*Louisville and Jefferson County Metropolitan Sewer District
700 West Liberty Street
Louisville Kentucky 40203-1911
502-540-6000
www.msdlouky.org*

Subject: Chenoweth Hills WQTC Elimination, Chenoweth Run and Chippewa PS Improvements
Minor Project Modification
IOAP Project No. S_JT_JT_NB01A_M_03_C
DOJ Case No. 90-5-1-1-08254

MSD is requesting approval of a proposed minor project modification to the Chenoweth Hills WQTC Elimination & PS Improvements project (IOAP Project No. S_JT_JT_NB01A_M_03_C). This modification is part of an overall adaptive management review of the approved 2012 IOAP Modification.

Chenoweth Hills WQTC Elimination, Chenoweth Run and Chippewa PS Improvements

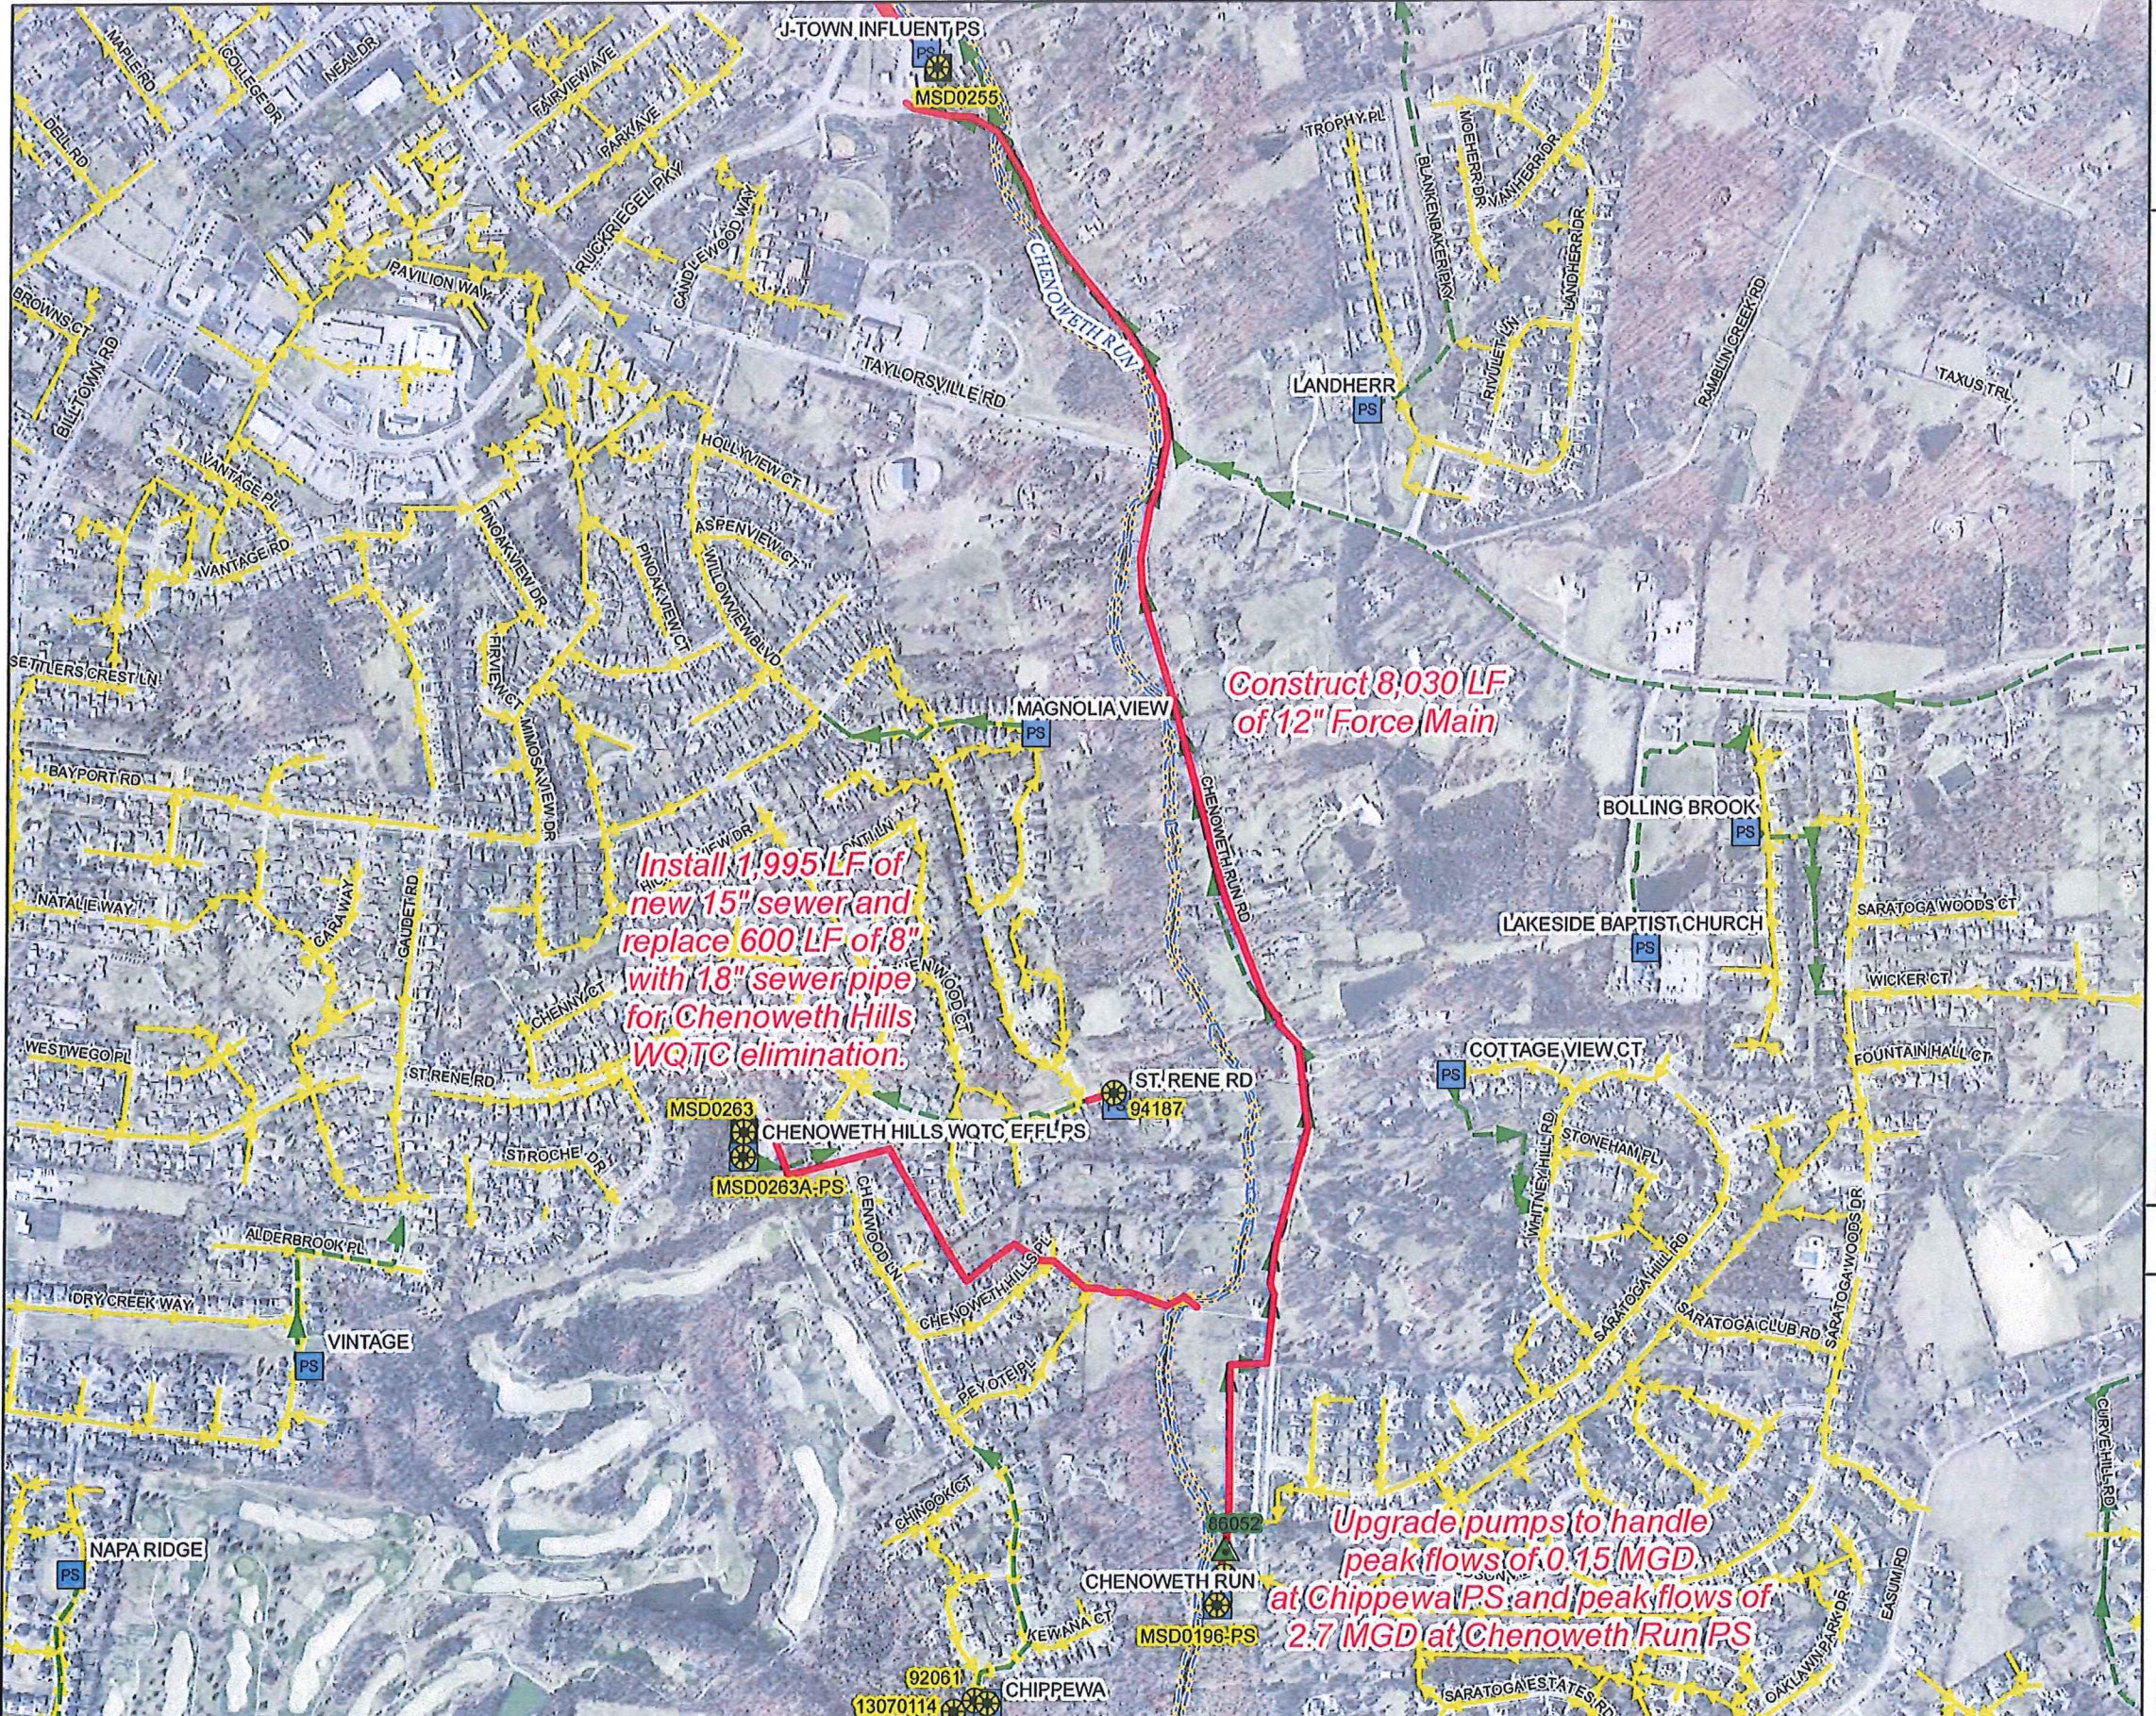
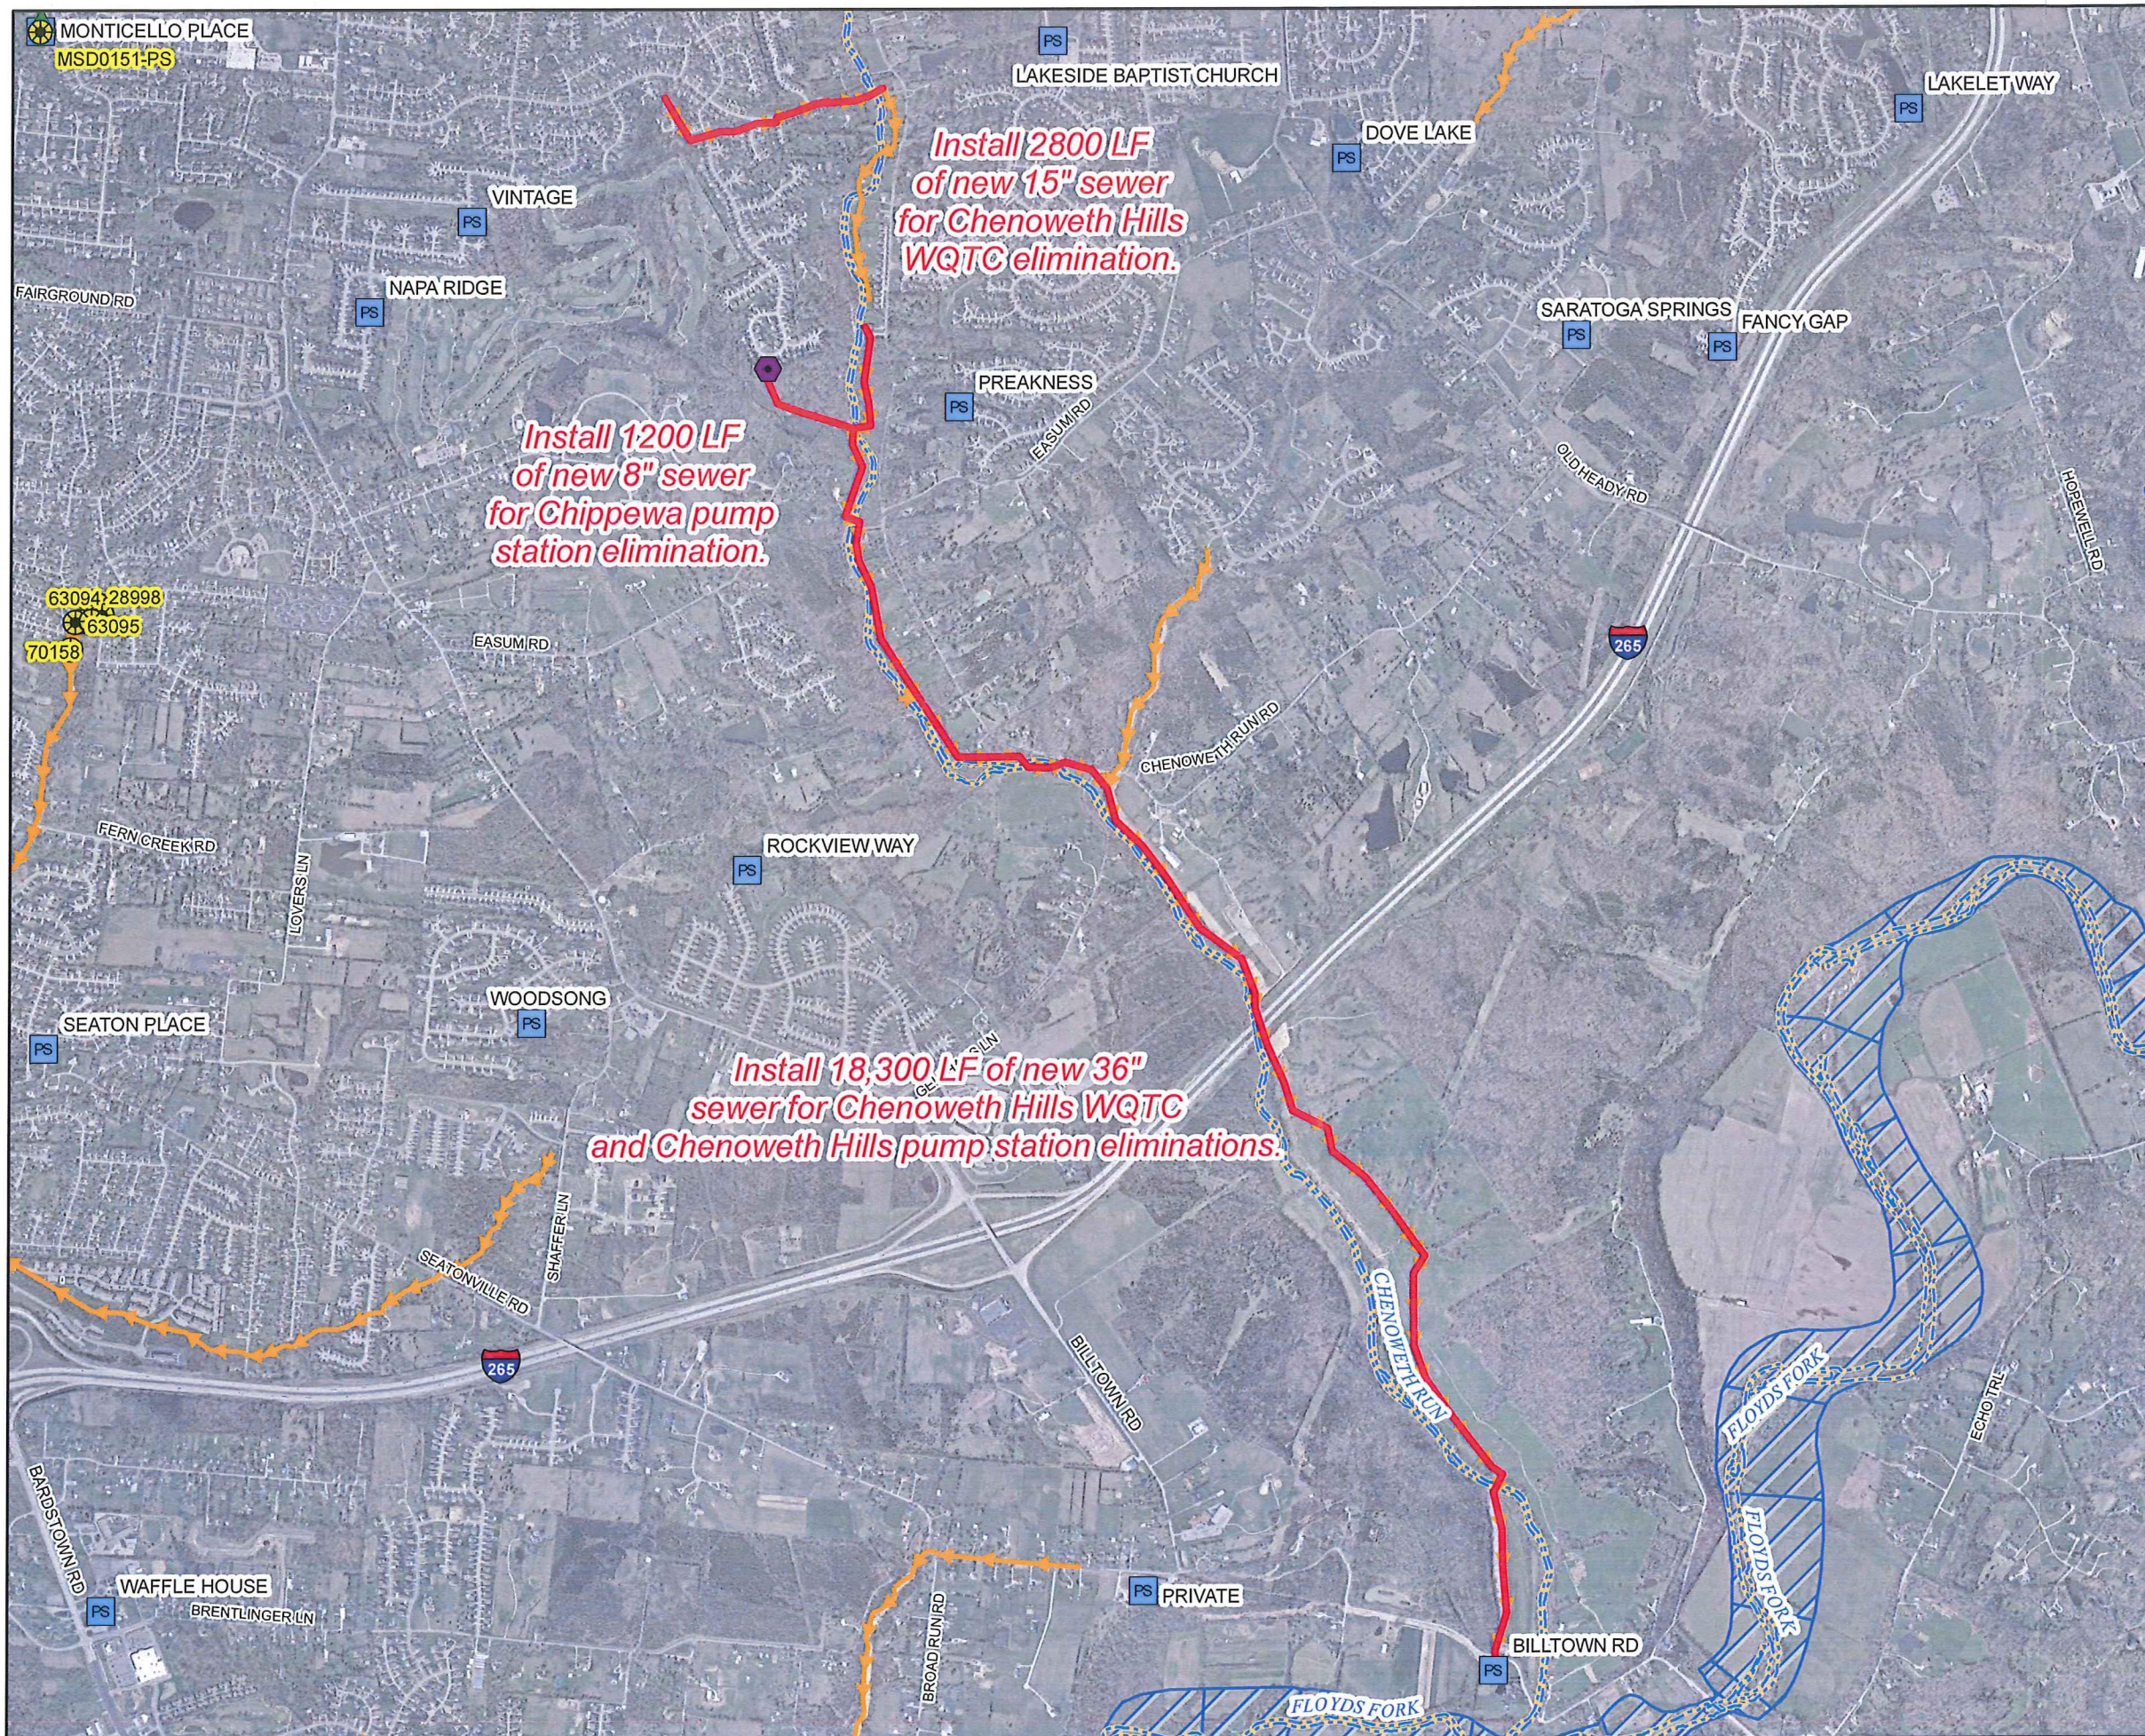
The project modification proposed constructs 2,800 LF of 15-inch and 1,200 LF of 8-inch diameter gravity sewer to allow elimination of the Chenoweth Hills WQTC, and also eliminate (not upsizing) the Chenoweth Run and the Chippewa Pump Stations. This provides the same level of protection as the original project, but at a greatly improved level of reliability since two existing pump stations are eliminated. No change in project schedule is proposed.

The original Chenoweth Hills WQTC Elimination Project was developed prior to the completion of the final Jeffersontown WQTC elimination plan submitted for regulatory review in March, 2010. It calls for diverting approximately one-third of the Jeffersontown WQTC flow south to the Cedar Creek WQTC, with the remainder of the flow diverted north to the Hikes Lane interceptor. Part of the infrastructure required for the diversion to the Cedar Creek WQTC was the construction of the Billtown Road Interceptor. This interceptor provides an outlet for the gravity sewer elimination of the Chenoweth Hills WQTC and the Chenoweth Hills and Chippewa Pump Stations. This solution provides the same 1.82-inch 3-hour cloudburst level of protection as the original project, but with greatly improved reliability since two pump stations are eliminated. Flows from all three sites will be diverted to the Cedar Creek WQTC.

Project Description This alternative includes eliminating Chenoweth Hills WQTC, Chenoweth Hills PS, and Chippewa PS. Install 18,300 LF of new 36" sewer, 2800 LF of new 15" sewer for Chenoweth Hills WQTC diversion, and 1200 LF of new 8" gravity sewer to eliminate Chippewa pump station.
